Hood Latch Assembly, Retrofit AN

FSB 821-027 Hood Latch Assembly, Retrofit

(January 2022)

On certain Mack Anthem model trucks built from January 29th, 2018 to present customers may experience difficulty opening the hood, particularly in cold weather climates.

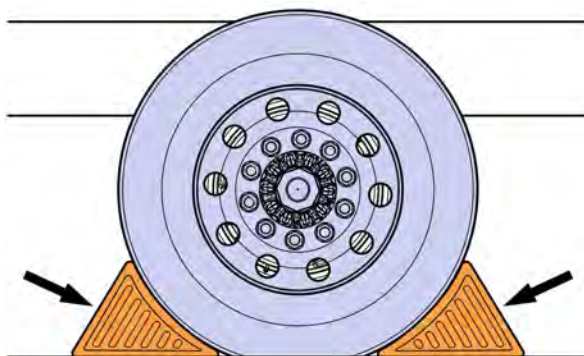
If this condition exists, follow the procedures outlined in this Field Service Bulletin (FSB).

Remove the hood release latch/cable assemblies and install the rubber hood latch straps as per instructions outlined in this Field Service Bulletin (FSB).
